REMARKS

This Application has been reconsidered in light of the Office Action dated March 3, 1997, and the references cited therein. Applicant hereby requests further examination and reconsideration of the Application in view of the foregoing amendments.

Proposed
drawing change

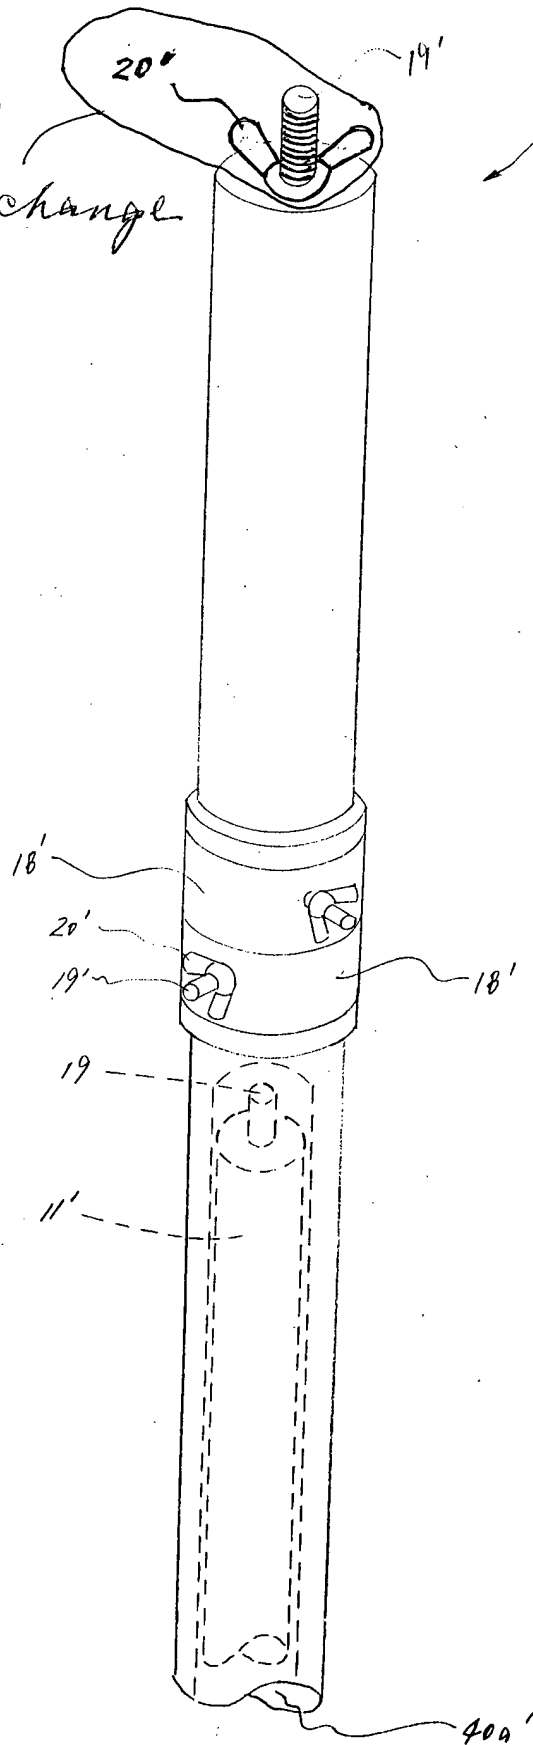
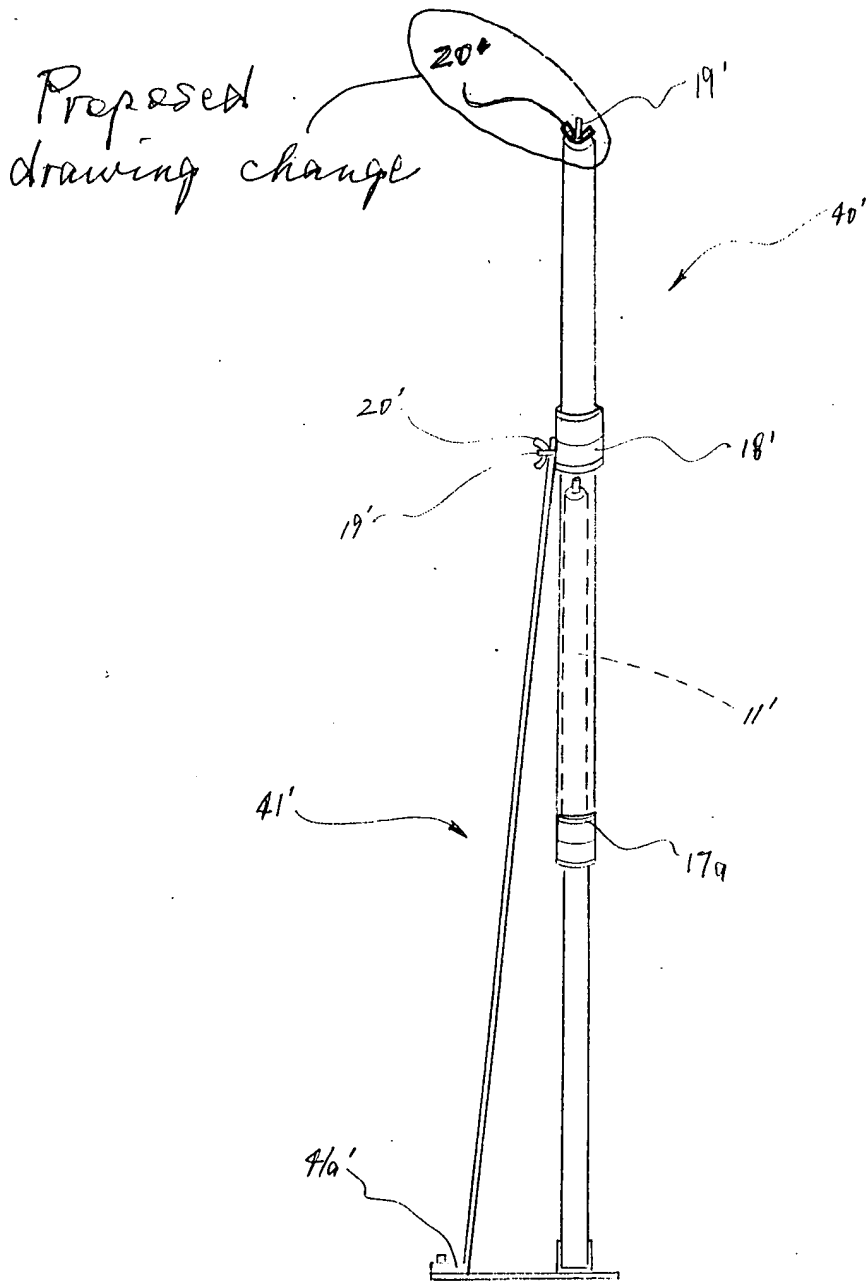
The drawings are objected to because the drawings do not include certain reference signs mentioned in the description. 37 CFR § 1.84(f) states, "reference signs not mentioned in the description shall not appear in the drawing and vice versa."

The following reference signs are not included in the drawings: "16' " as discussed on page 18 line 1; "20' " on top of pole 40' as discussed on page 18 first paragraph. Correction is required.

Accordingly, Applicant has amended the specification to conform the reference signs mentioned therein to be drawings. Further, Applicant is submitting herewith proposed drawing corrections to conform the drawings to the specification.
